**Clicking Noise From Front of Vehicle –  
Brake Disc Dust Shield – Install Revised  
Dust Shield**MODEL 1995-96 MY  
Sedan Range  
VIN  
720001-ON**ISSUE:**

ILLUSTRATION 1

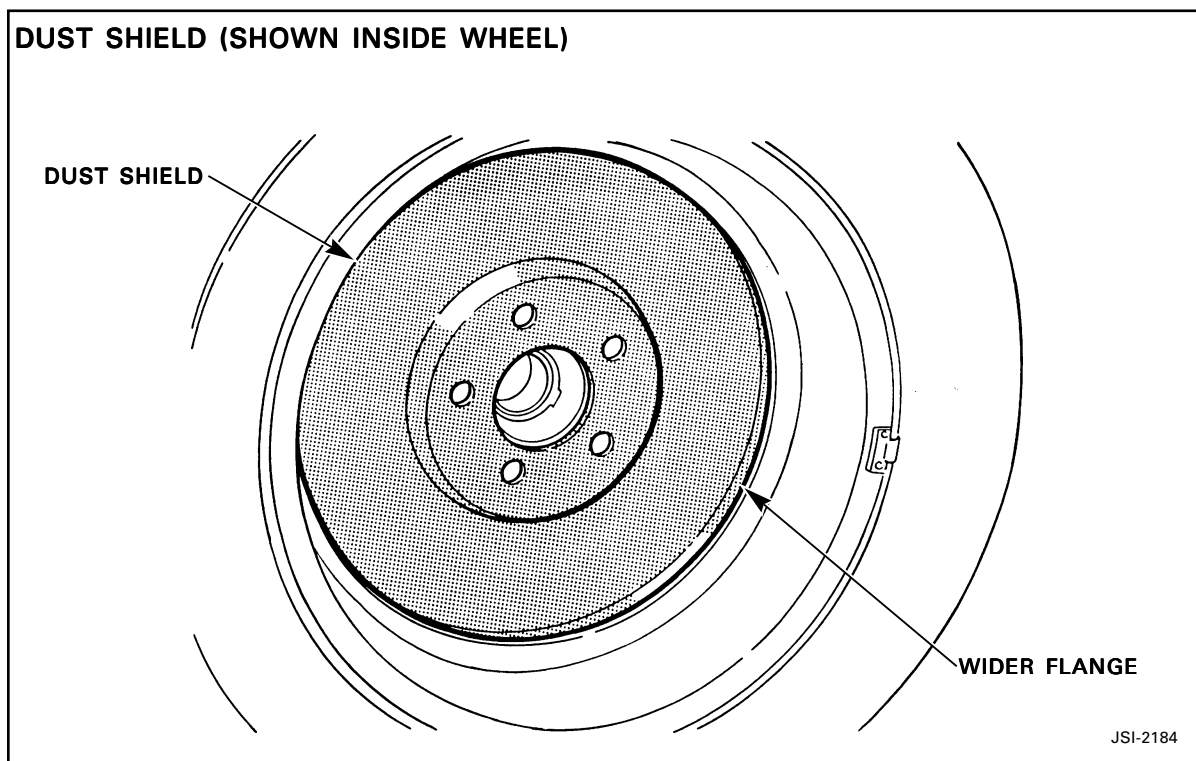
Some 1995-96 MY Sedan Range vehicles equipped with 16 inch alloy wheels **and** accessory dust shields (Illustration 1) may experience a clicking noise from the front of the vehicle at low speeds. The noise may be caused by one dust shield rubbing against the alloy wheel.

After verifying a customer complaint of clicking from the front of the vehicle, determine on which side of vehicle the noise is apparent. Replace the dust shield on that wheel with a revised dust shield. In addition to the part number label, the revised dust shield can be identified by a wider flange with foam rubber blocks attached.
